LLFA Pre-application Consultation Response

From: Francis, Jack <Jack.Francis@wiltshire.gov.uk>
Sent: 16 October 2020 11:01
To: Medlin, Eileen
Subject: 20/08644/PREAPP - Land Off Westbury road, Warminster
Attachments: FZ Risk.JPG; SW Risk.JPG; GW Risk.JPG

Application No:	20/08644/PREAPP
Proposal:	Outline planning application for residential development of up to 250 dwellings with associated and ancillary development
Site Address:	Land North Of 6 The Woodlands, Warminster, Wiltshire,

Land Off Westbury road, Warminster

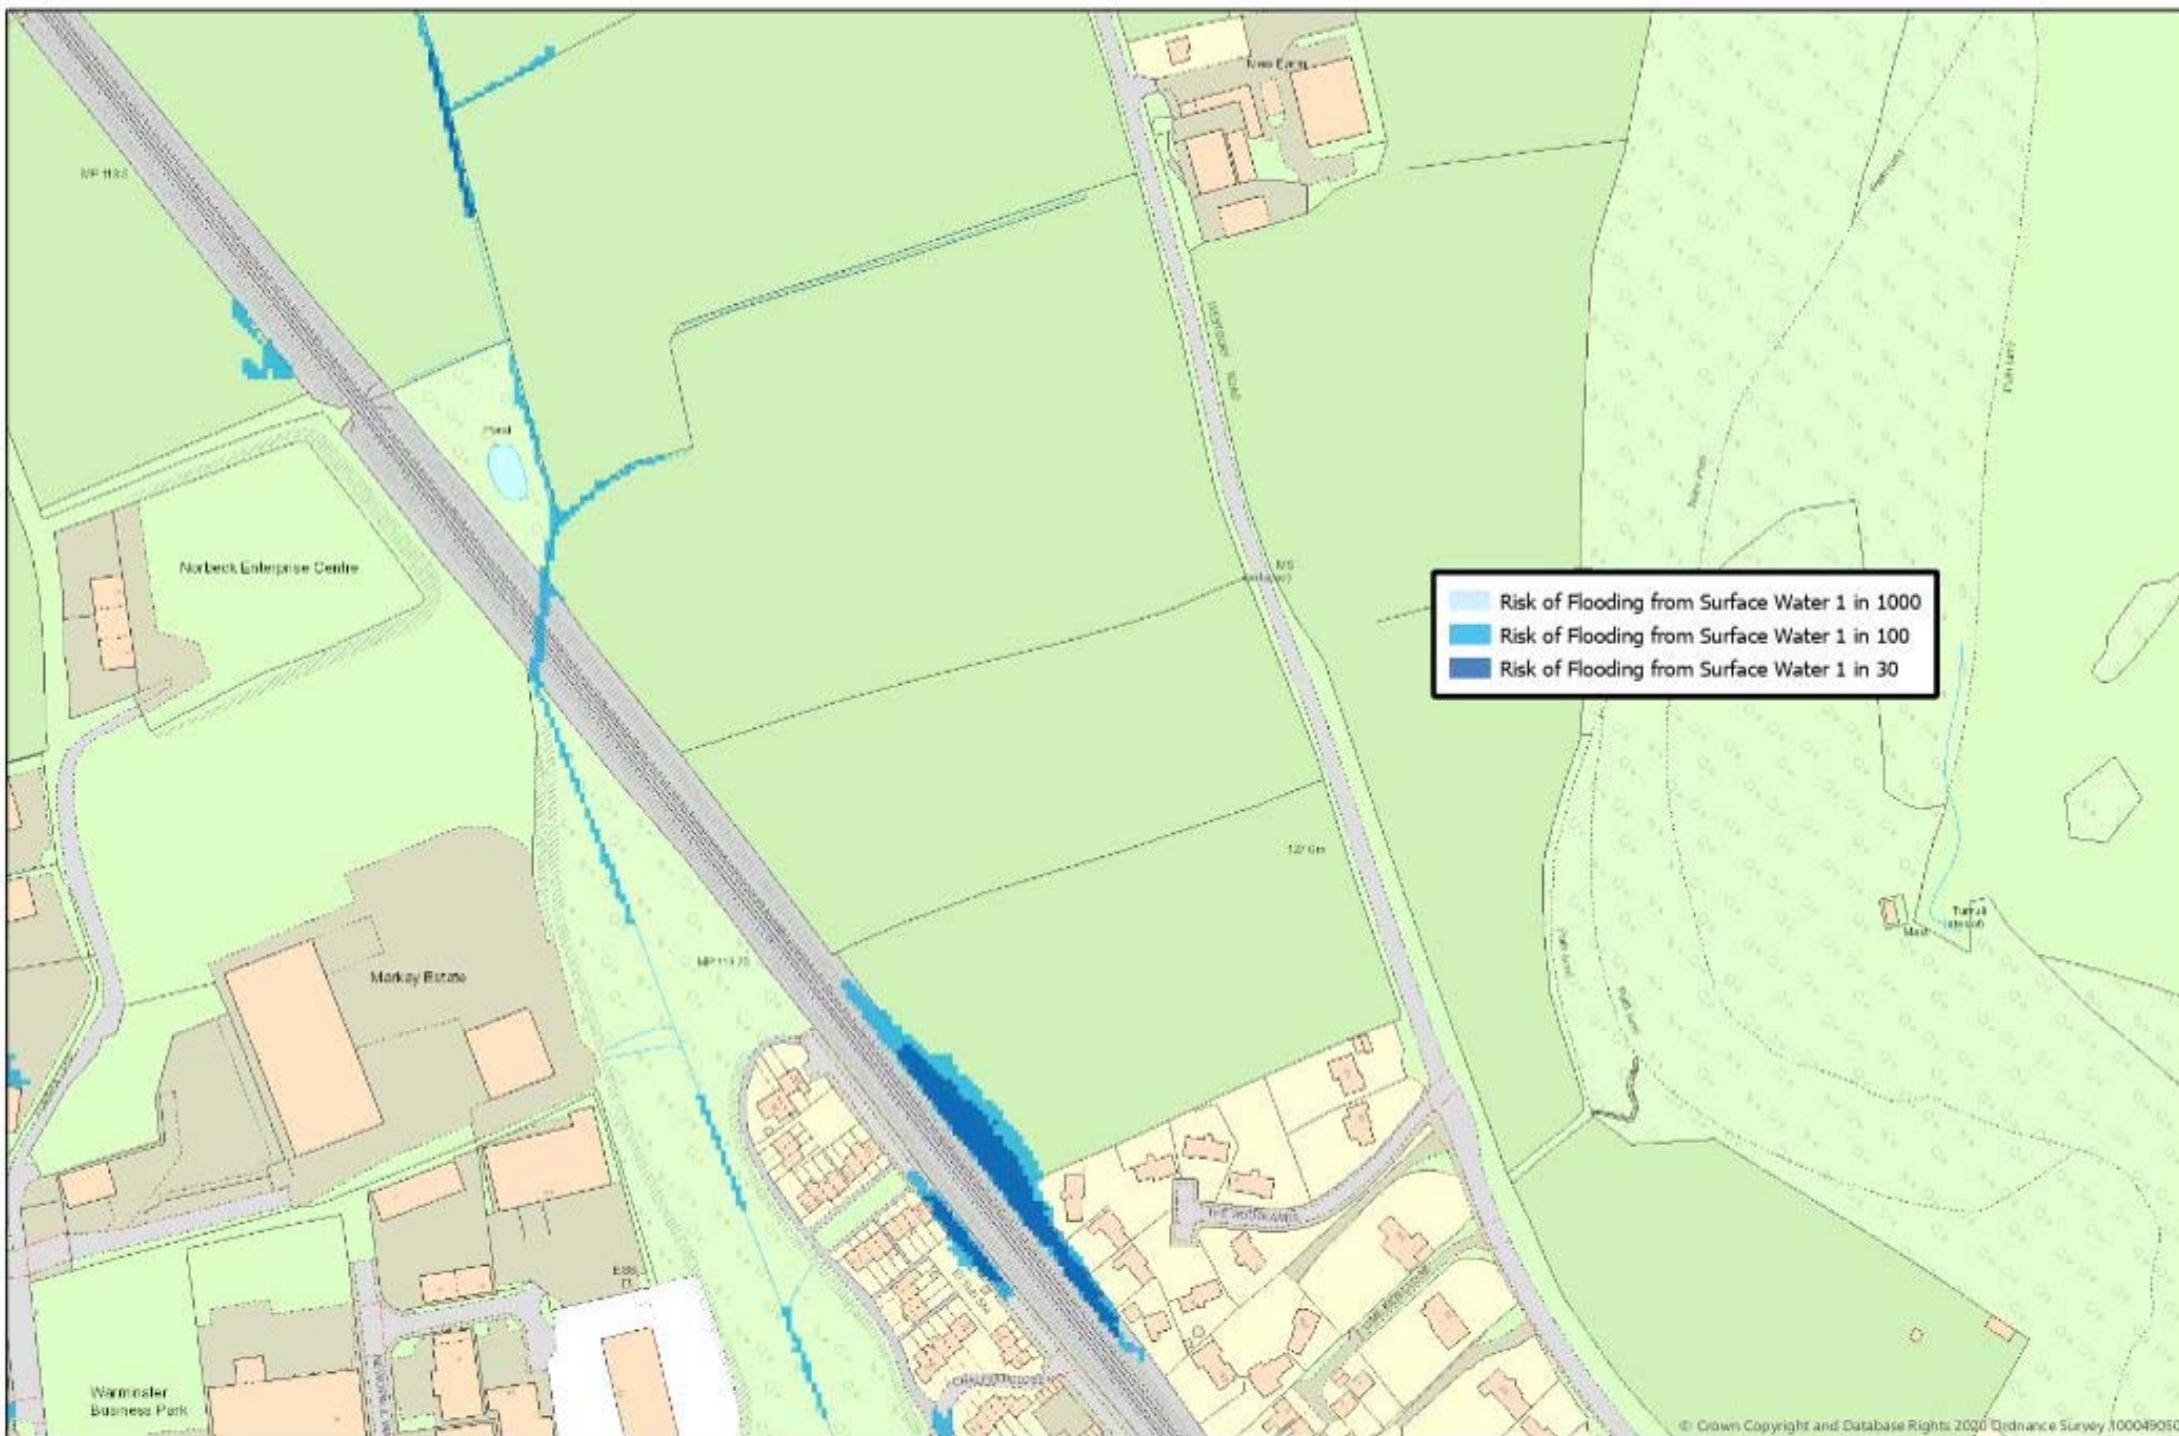
The northern part of the site is in flood zones 2 and 3. Flood risk maps can be viewed on Wiltshire Council's [Strategic Flood Risk Assessment Data Explorer](#) (see appendix B, C & D) and the [Environment Agency's Flood Map for Planning](#)

Part of the site is also predicted to be at risk of surface water flooding in the 100 year plus climate change scenario. Flood risk maps can be viewed on Wiltshire Council's [Strategic Flood Risk Assessment Data Explorer](#) (see appendix E & F).

Groundwater Flood Risk

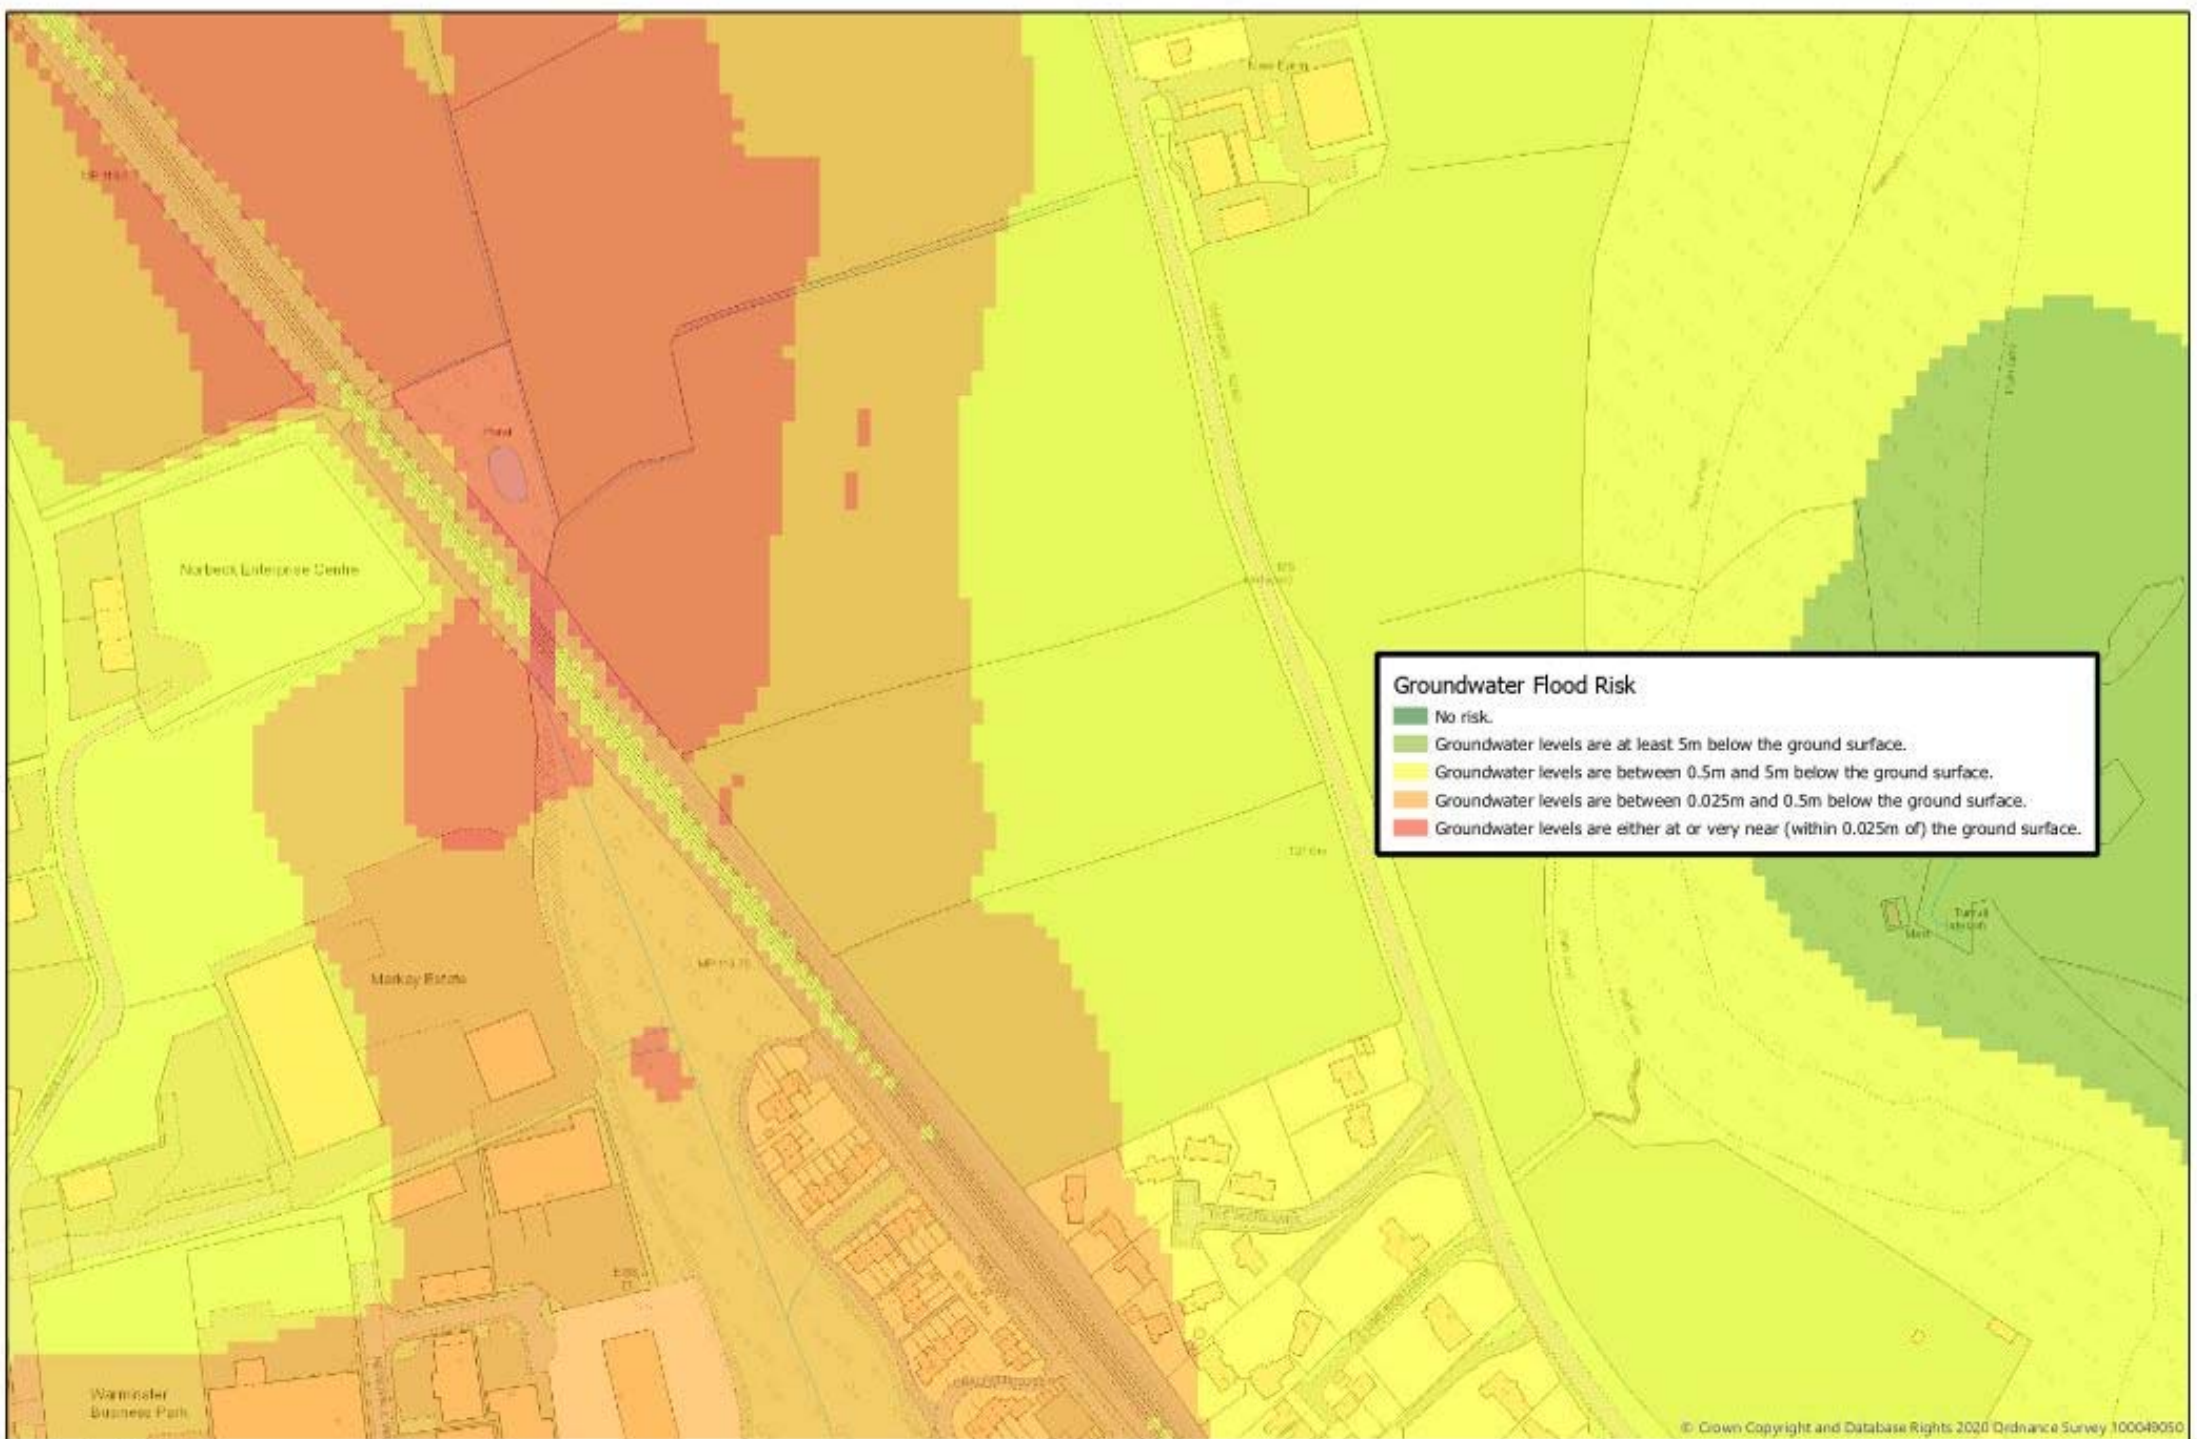
The Northern part of the site may be at risk of groundwater flooding and high groundwater levels may impact on infiltration techniques. Groundwater levels are predicted to be between 0.025m and 0.5m below the ground surface. Flood risk maps can be viewed on Wiltshire Council's [Strategic Flood Risk Assessment Data Explorer](#) (see appendix G).
